## **Compatibility bands – ECE R13**

### **(Proposal from the Danish delegation)**

DIAGRAM 2

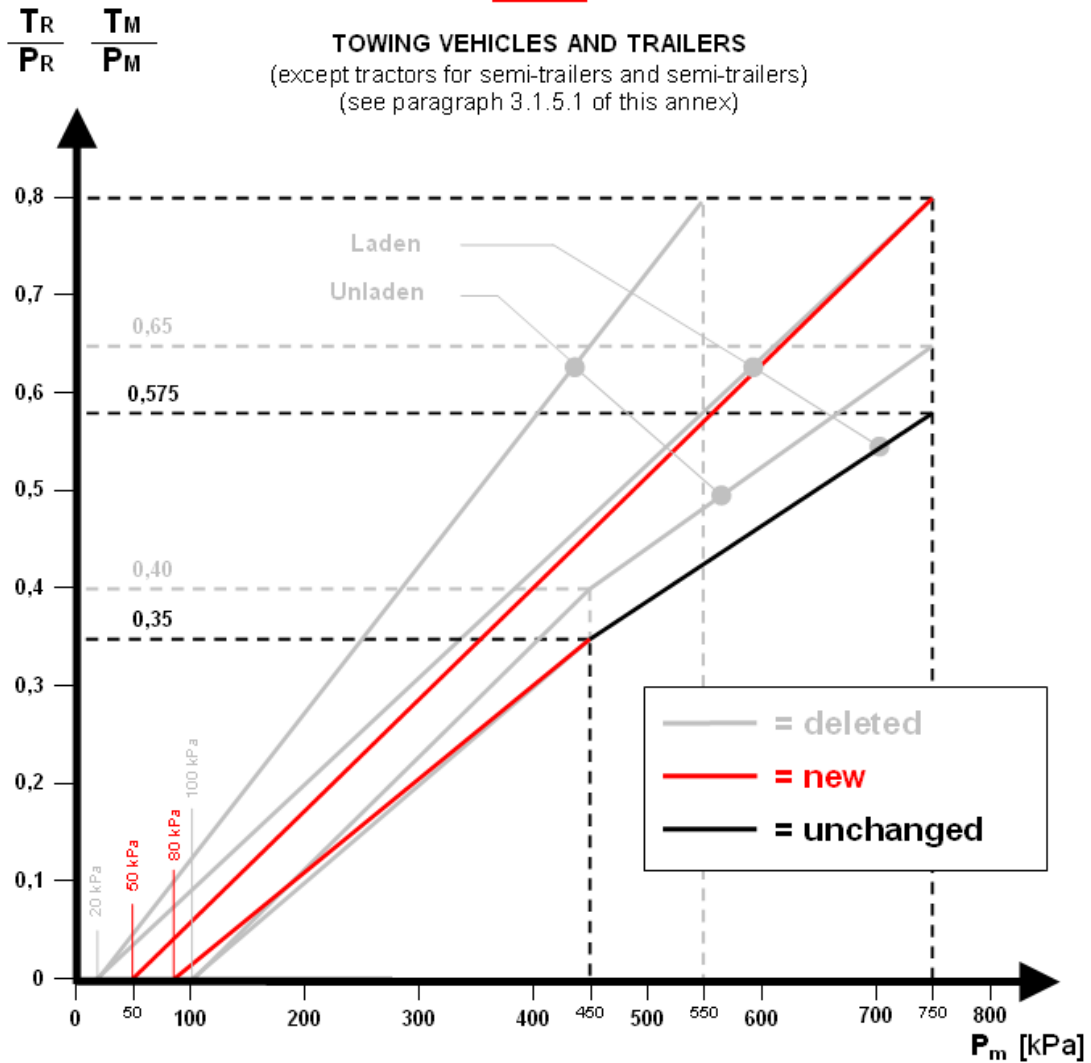
Brake compatibility between truck/tractor and trailer is enhanced by narrowing the limits for control line pressure versus brake rate in the area below 200kPa where most common brake events occur. The aim is to reduce the occurrence of too frequent exchange and disposal of not worn down brake pads due to sleeping and glazed brake linings thereby ensuring the presence of adequate brake performance throughout brake lining life.

To ensure compatibility not only in the full laden condition the compatibility bands should cover all load conditions in the area below 200kPa control line pressure.

Annex 10, diagrams 2, 3 and 4A, amend to read:

**Revised**

DIAGRAM 3

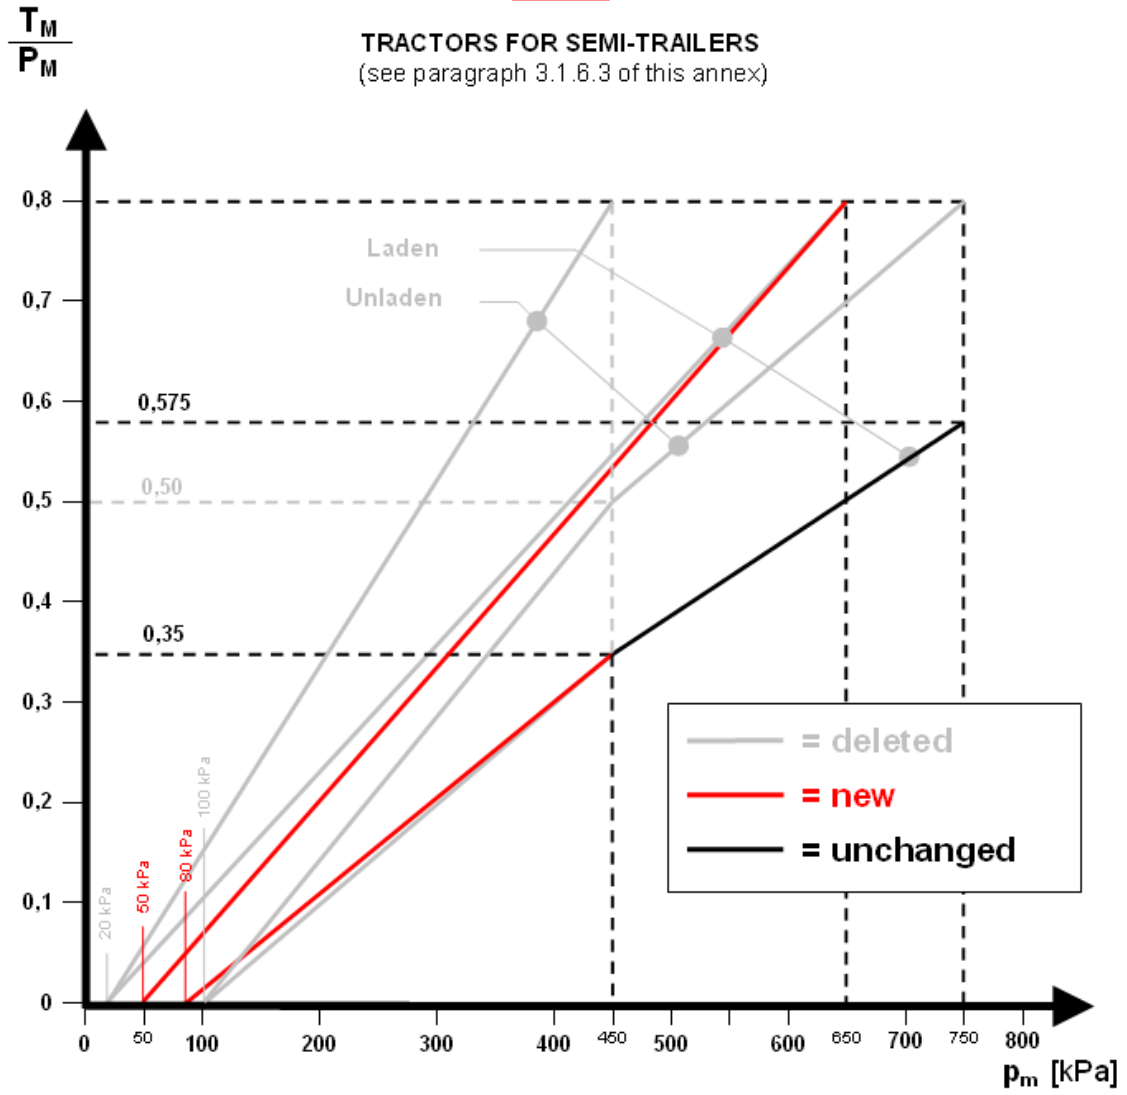
TRACTORS FOR SEMI-TRAILERS  
(see paragraph 3.1.6.3 of this annex)

Revised

DIAGRAM 4

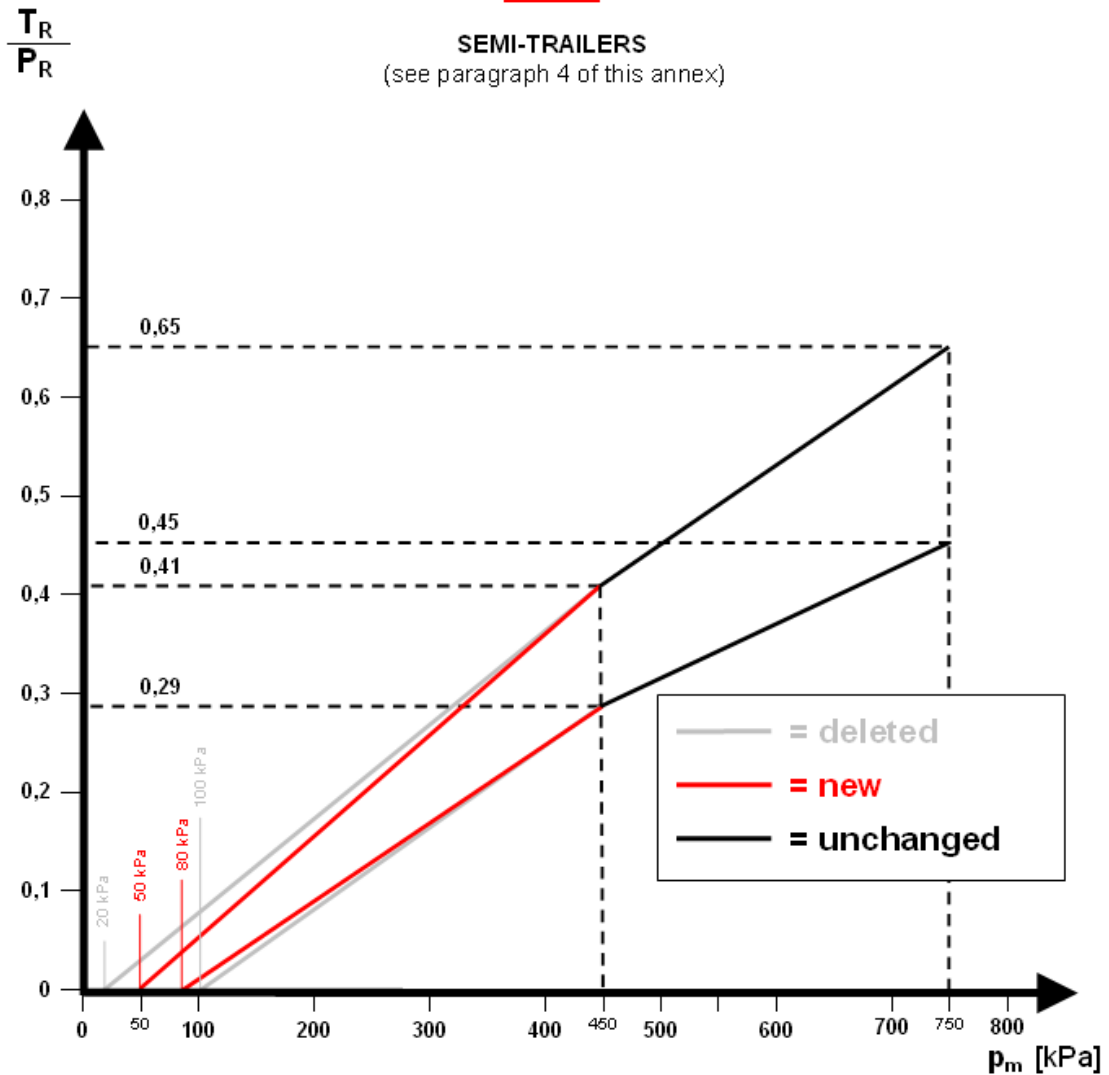
SEMI-TRAILERS

Revised
